**ROCKFORD BOARD OF EDUCATION  
INVITATION FOR BID ON SUPPLIES, MATERIALS, EQUIPMENT OR SERVICES  
FOR SCHOOL DISTRICT NO. 205  
ROCKFORD, ILLINOIS**

IFB No.        **17-40 Rockford Public School District 205 School B, Zone 1**

RE:        **ADDENDUM NO. 7**

Rockford Public School District 205  
School B, Zone 1  
Rockford, IL  
Cannon Project No. 005005.00

**C14**

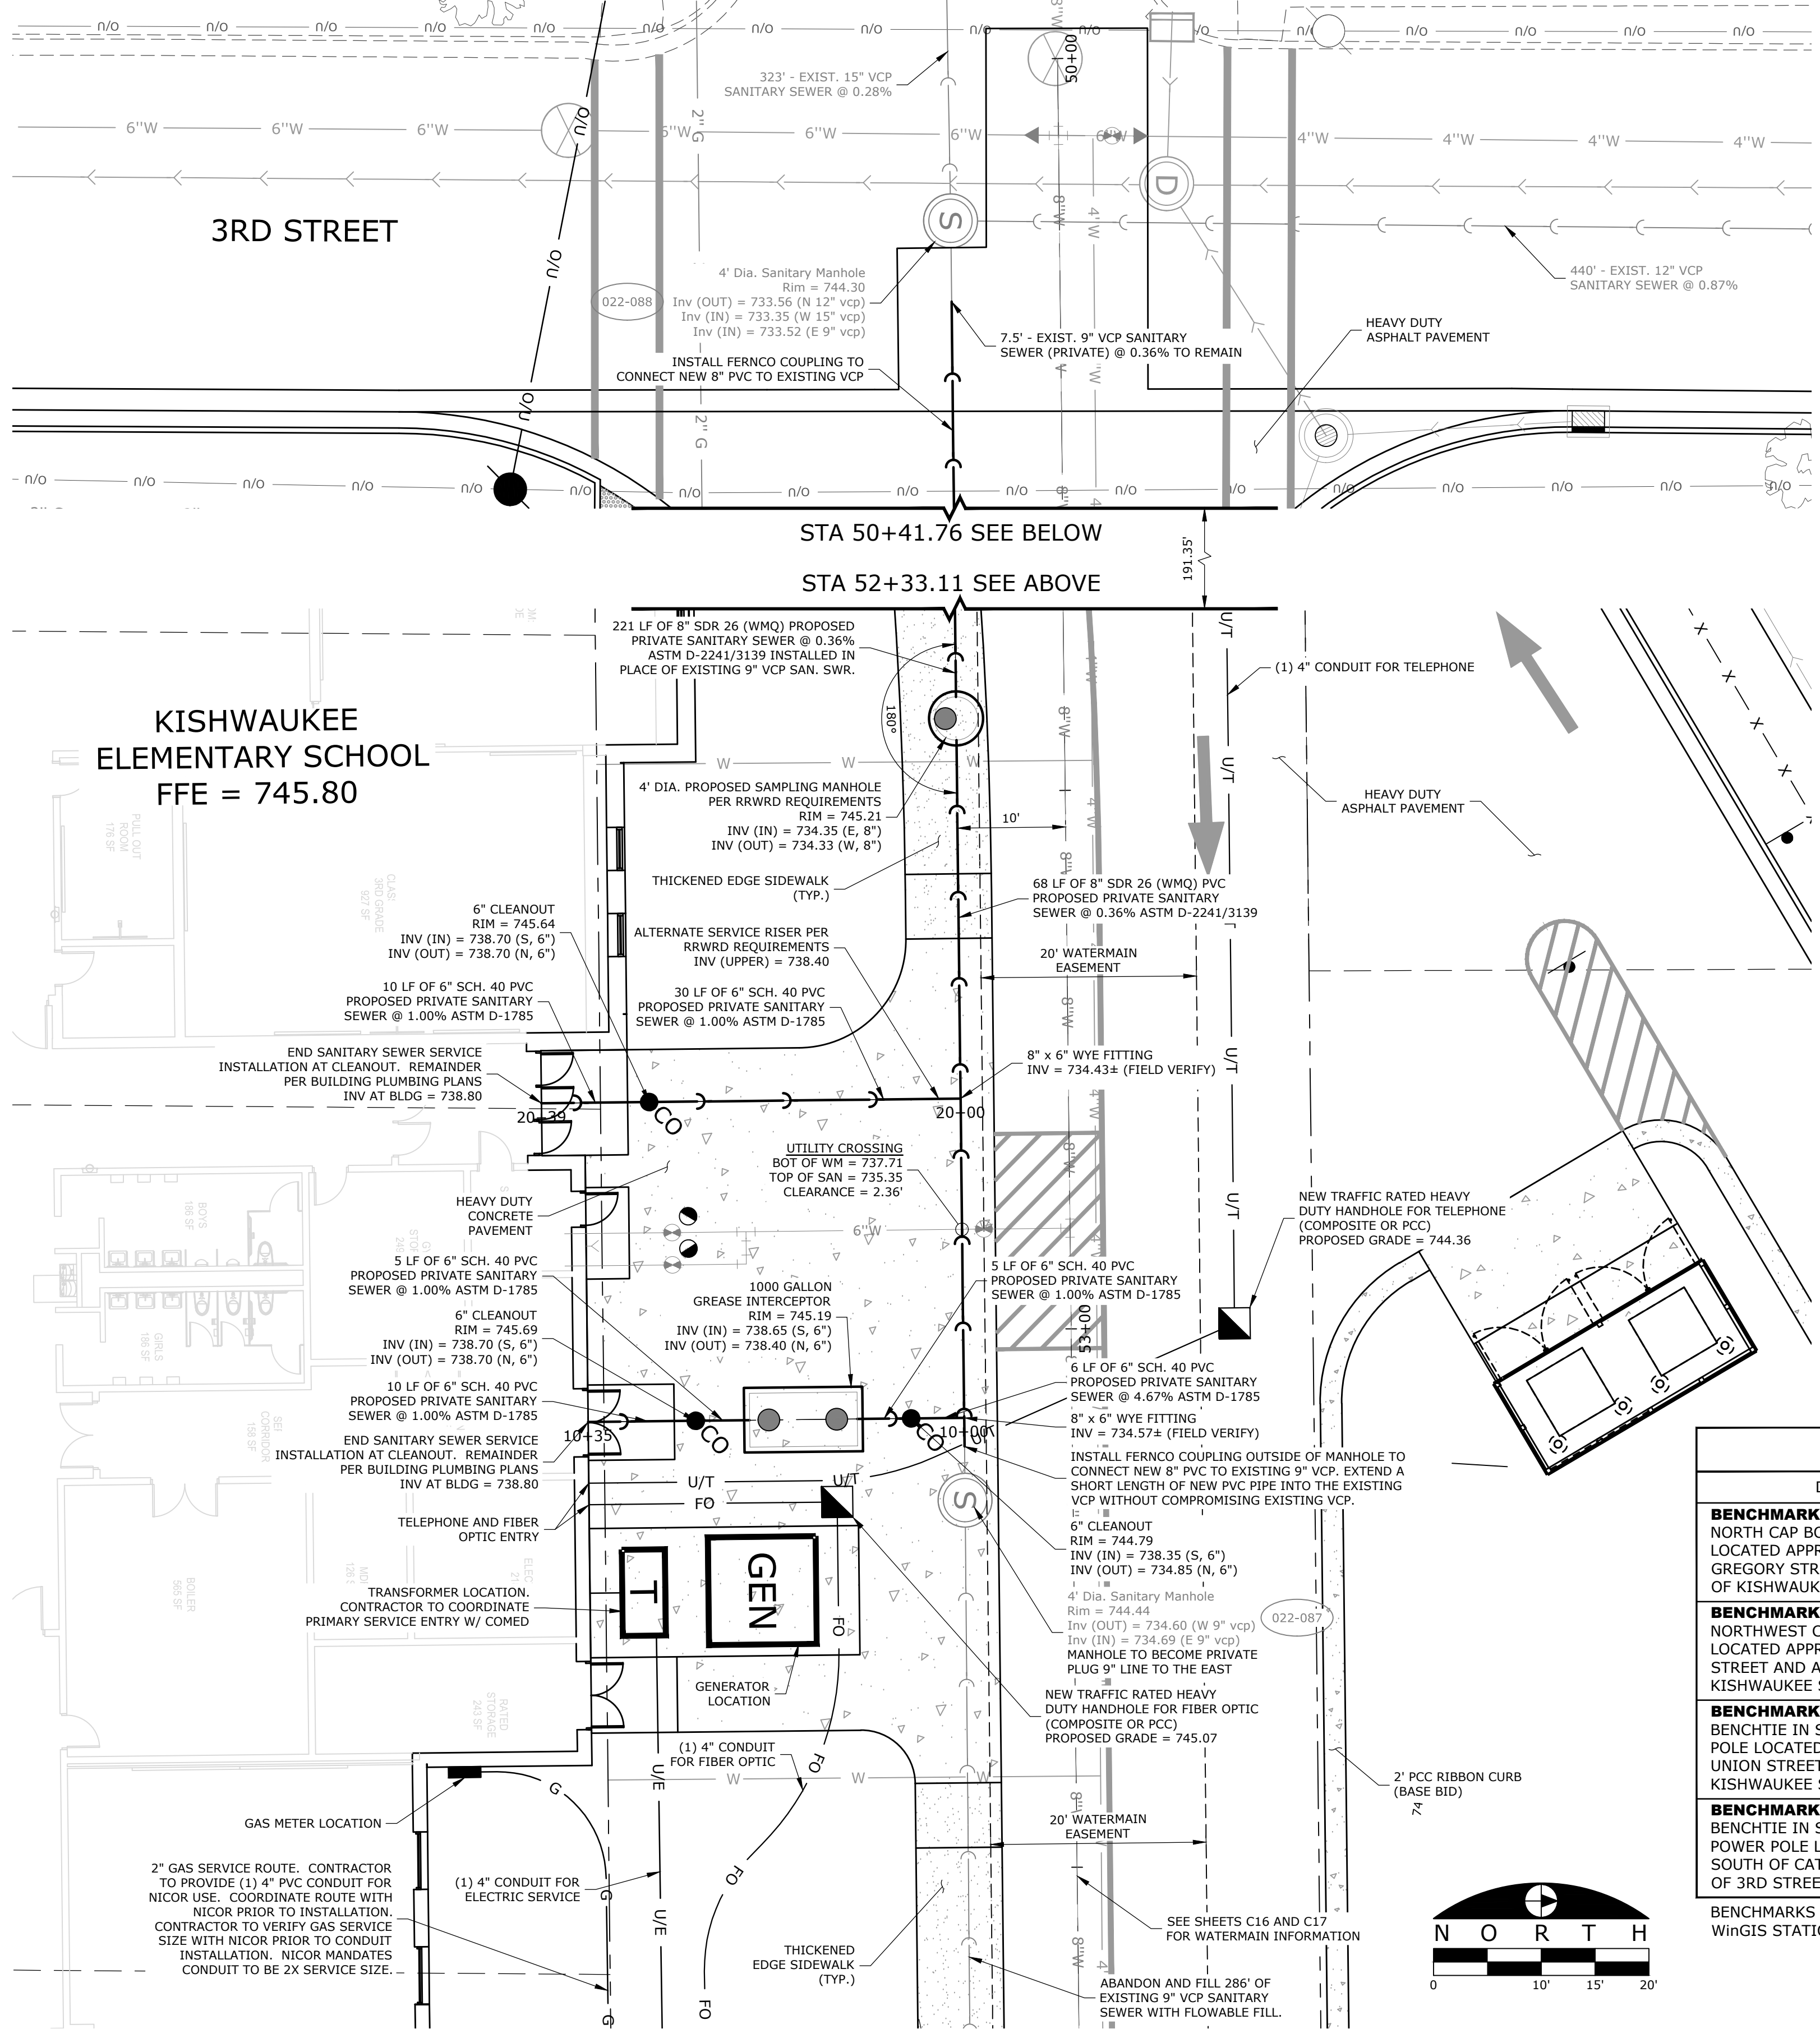
7. C14 – UTILITY PLAN

- A. Added description of alternate 6 work as well as note regarding existing site utilities.

ALTERNATE 6 WORK SCOPE:  
ALTERNATE 6 INCLUDES THE WORK REQUIRED TO PROVIDE CERTAIN ENHANCEMENTS TO THE PROPOSED WATER SYSTEM IN ORDER TO MAKE THE SYSTEM MORE FUNCTIONAL, ONCE COMPLETE AND TURNED OVER TO THE CITY OF ROCKFORD. SPECIFICALLY, THESE IMPROVEMENTS INCLUDE A NEW 8" VALVE AT THIRD STREET, NORTH OF CATLIN, DISCONNECT SEVENTH AVENUE MAIN FROM EXISTING SIX INCH MAIN AND CONNECT TO 12 INCH MAIN WITHIN KISHWAUKEE STREET; AND ABANDONING SIX INCH MAIN BY INSTALLING A PLUG AND FILLING THE LINE WITH FLOWABLE FILL PER IDOT REQUIREMENTS. ALTERNATE 6 ITEMS ARE SHOWN ON THE DRAWINGS.

NOTE: ALL EXISTING SITE UTILITIES TO REMAIN ACTIVE UNTIL EXISTING BUILDING IS DEMOLISHED

**C15**

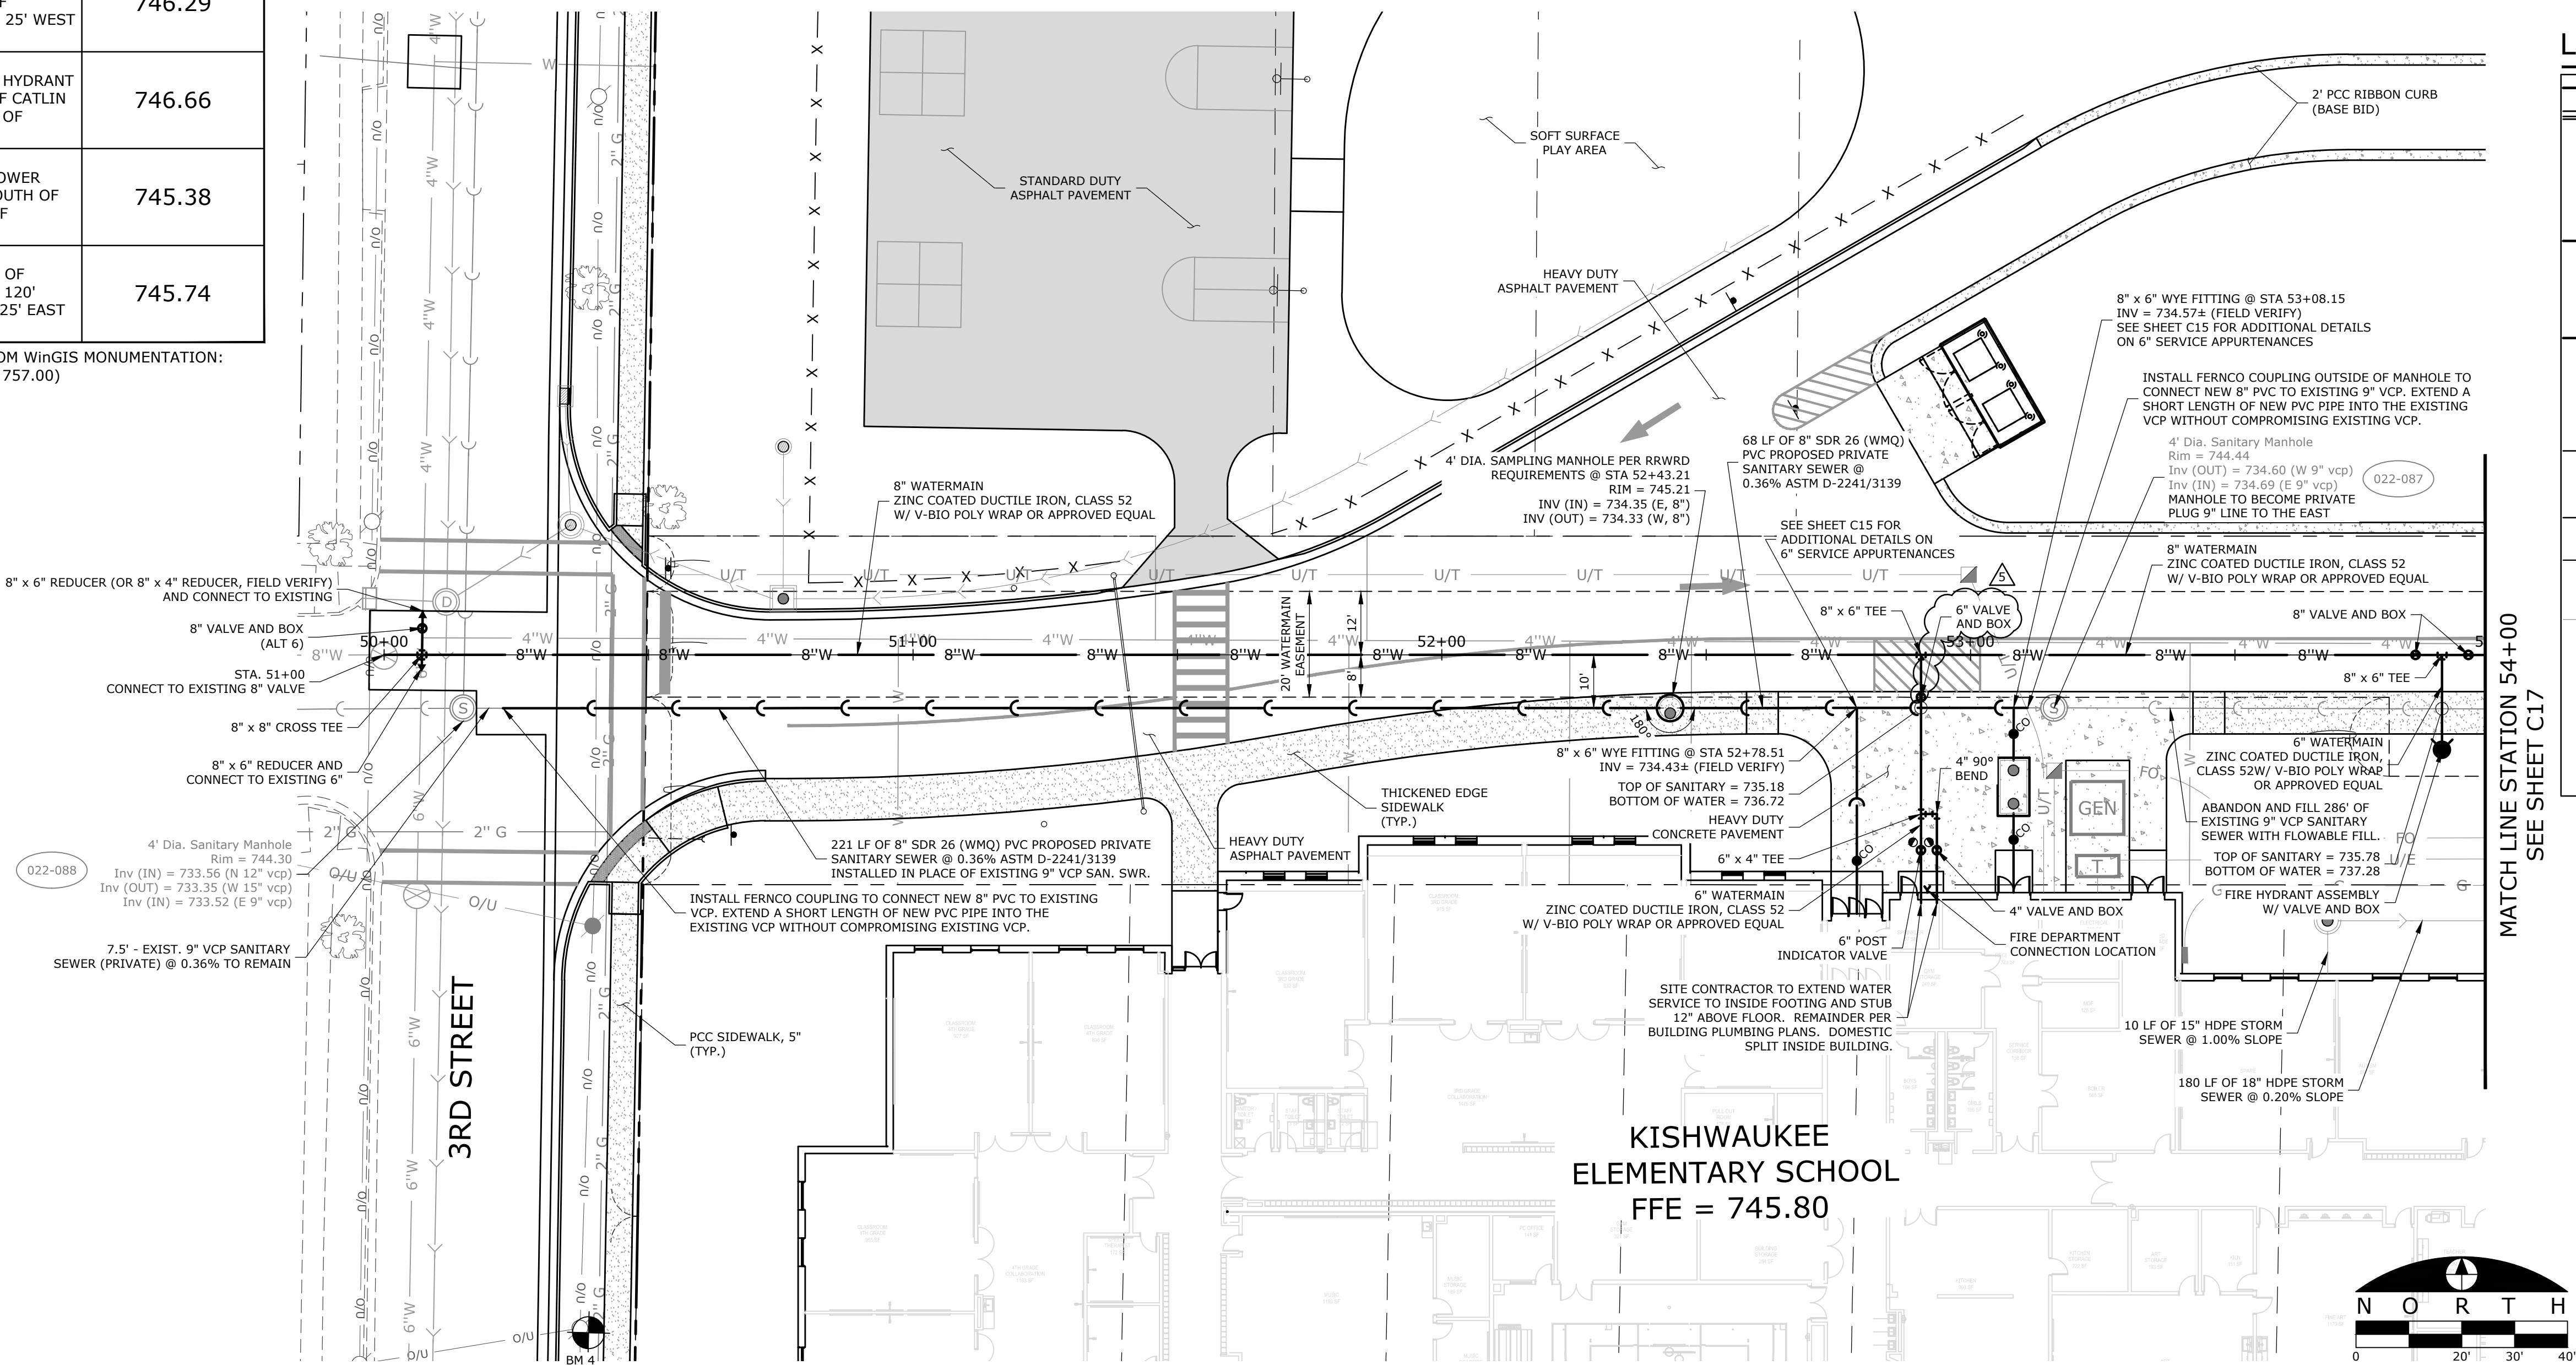
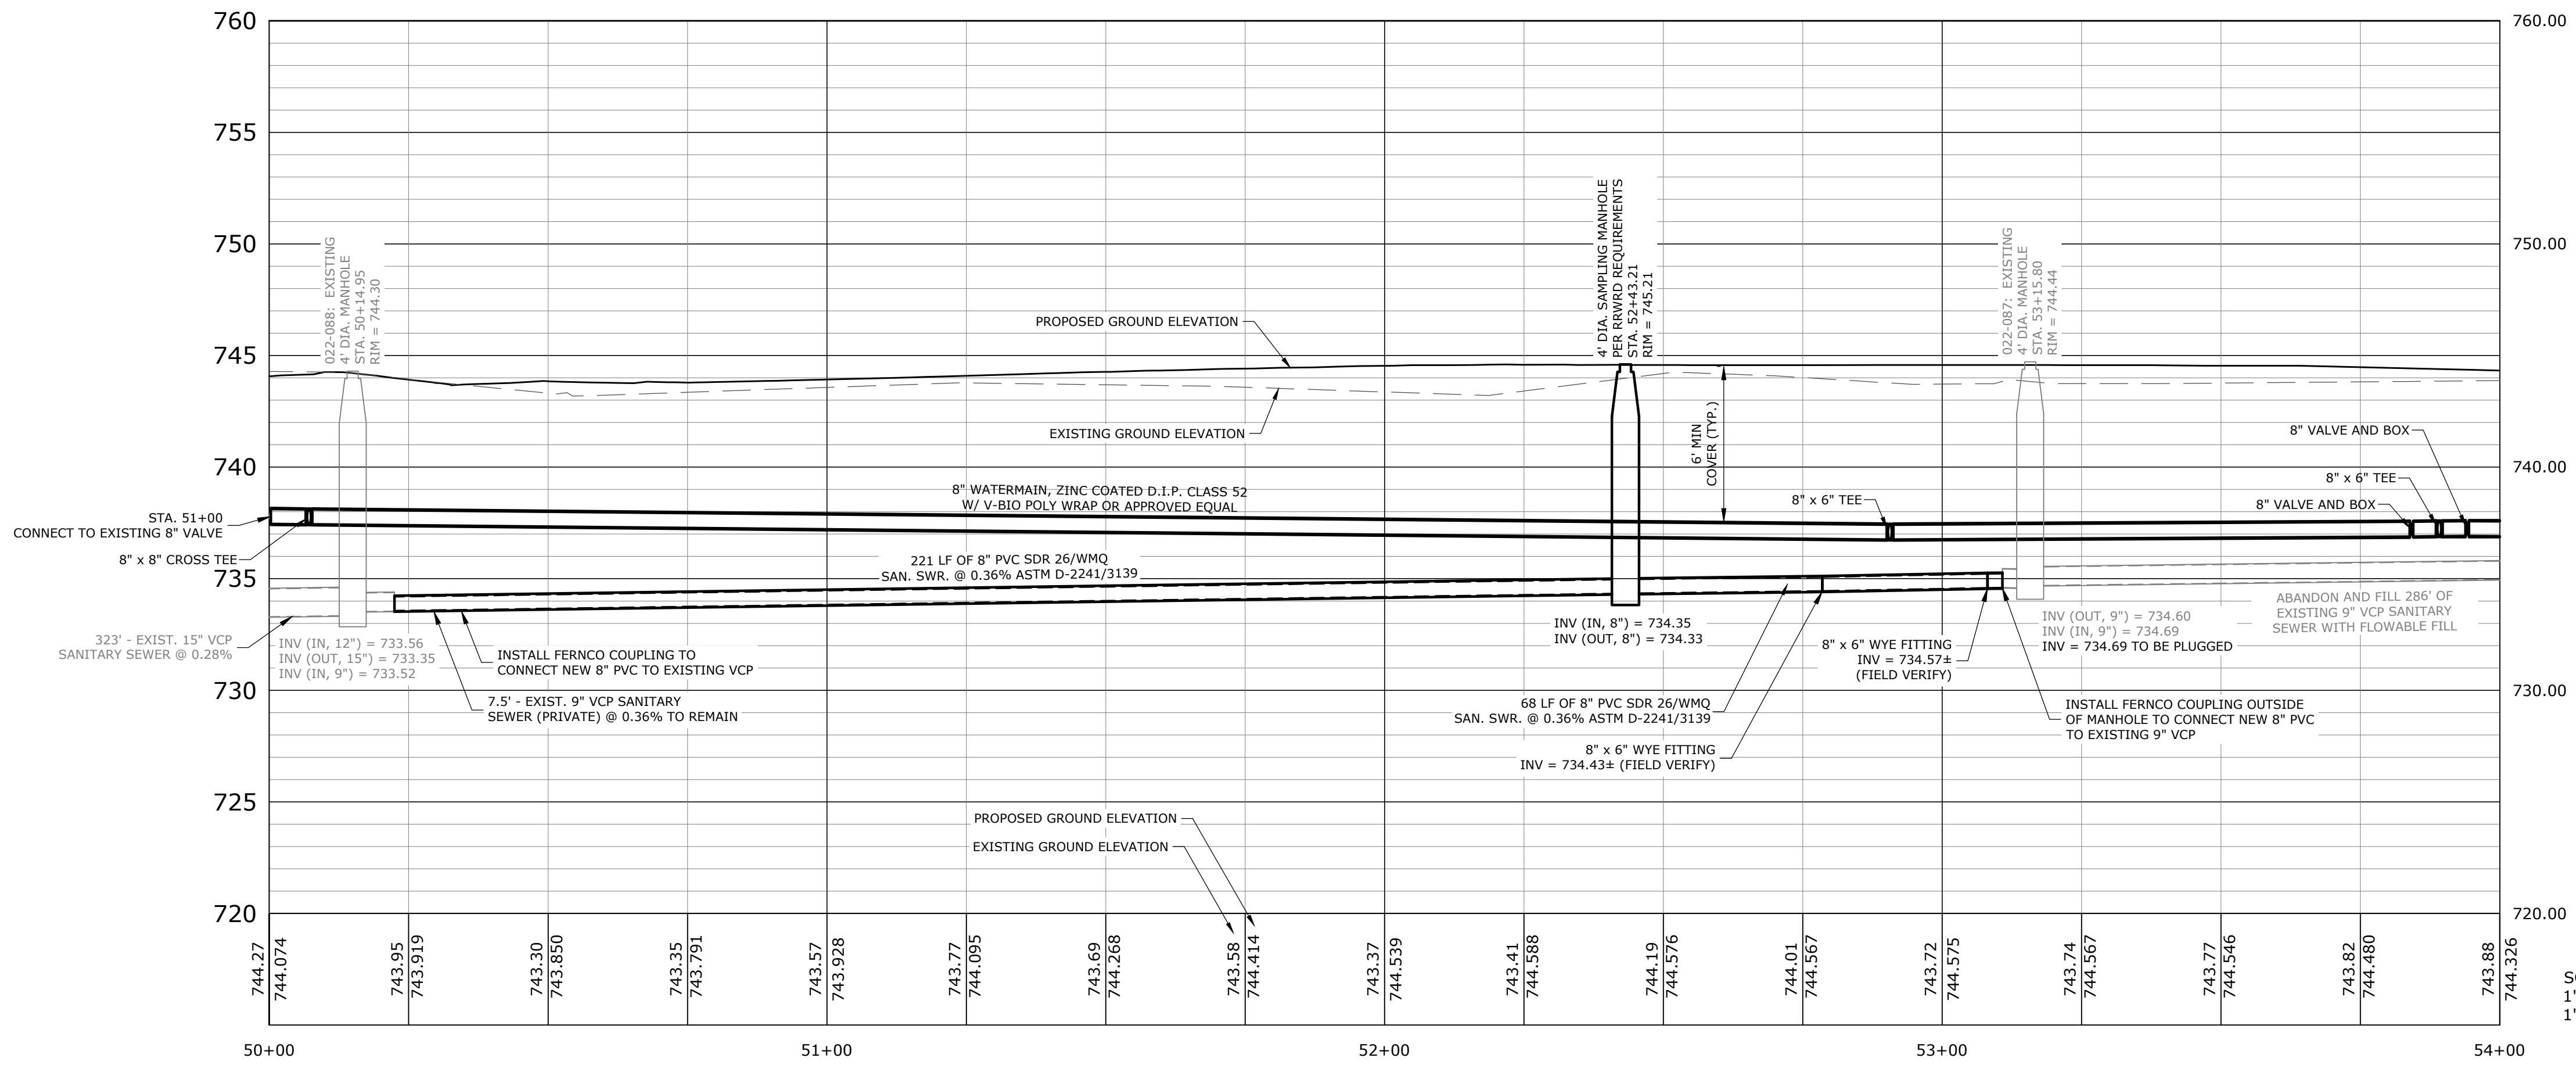
8. C15 – UTILITY ENTRY PLAN AND SANITARY PROFILES

- A. Added note regarding existing site utilities.

NOTE: ALL EXISTING SITE UTILITIES TO REMAIN ACTIVE UNTIL EXISTING BUILDING IS DEMOLISHED
